ADDENDUM "3"

PROJECT # 8312.01
 SUBJECT ADDENDUM #3
 SUBJECT NAME NEW SCIENCE & CLASSROOM BUILDING

**ADDENDUM NO. 3
NEW SCIENCE & CLASSROOM BUILDING
AT CAMDEN COUNTY COLLEGE
BIDDER QUESTIONS**

DATE 8/26/10
 HSB
 SK-S
 21

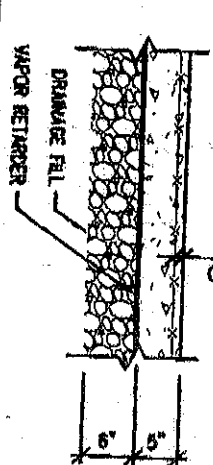
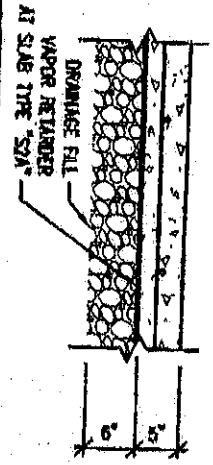
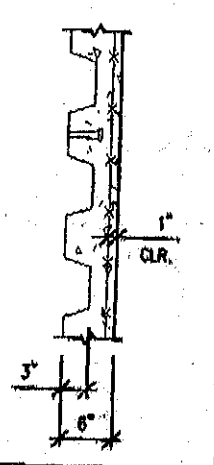
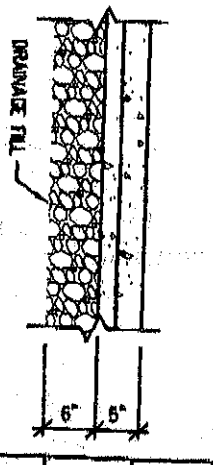
4. DRAWING S1-01
 - a. REVISE drawing as shown on Sketch No. SK-S21 attached herewith.
5. DRAWING P2-01A
 - c. Under the heading "NOTES:", ADD the following:

TYPICAL SLAB TYPES

TYPE	SECTION	SECTION			DESCRIPTION
		STUD	DECK	W.M.F.	
"S1"		STUD	---	6x6-W2.9xW2.9	SLAB TYPE "S1" 5" CONCRETE SLAB-ON-GRADE WITH 6x6-W2.9xW2.9 W.M.F. WITH FIBER REINFORCEMENT AT MANUFACTURER'S RECOMMENDED RATE, BUT NOT LESS THAN 1.5 LB/CU YD. OVER VAPOR RETARDER AND 6" DRAINAGE FILL.
"S2" "S2A"		STUD	---	---	SLAB TYPE "S2" & "S2A" 5" CONCRETE SLAB-ON-GRADE REINFORCED WITH #5@18" C/E EACH WAY OVER 6" DRAINAGE FILL. PROVIDE PENETRATING CONCRETE SEALER OVER SLAB SURFACE. PROVIDE VAPOR RETARDER AT SLAB TYPE "S2A"
"S3"		STUD	3/4" x 6x6" 	6x6-W2.9xW2.9	SLAB TYPE "S3" 5" STRUCTURAL SLAB CONSISTING OF 5" NORMAL WEIGHT CONCRETE WITH 6x6-W2.9xW2.9 W.M.F. OVER GALVANIZED 5" - 18 GA. COMPOSITE DECK WITH MINIMUM DECK PROPERTIES: Sp=0.583 in ³ /ft, Sm=0.620 in ³ /ft, I=0.993 in ⁴ /ft. SET TYPICAL DETAILS ON SB-03 & SB-04 FOR ADDITIONAL SLAB REINFORCING.
"S4"		STUD	---	---	SLAB TYPE "S4" 5" CONCRETE SLAB-ON-GRADE REINFORCED WITH #5@18" C/E EACH WAY OVER 6" DRAINAGE FILL. PROVIDE PENETRATING CONCRETE SEALER OVER SLAB SURFACE. SEE CIVIL DRAWINGS FOR EXACT OF STAMPED CONCRETE PATTERN BETTER TO SPECIFICATION SECTION 32013.

CONTRACTOR SHALL PROVIDE MINIMUM CONCRETE COVER OVER DECK STUDS PLUS ADDITIONAL POWDERED CONCRETE AS REQUIRED TO PROVIDE FLOOR SLAB WITH FLATNESS TOLERANCES OF SPECIFICATION SECTION 3300
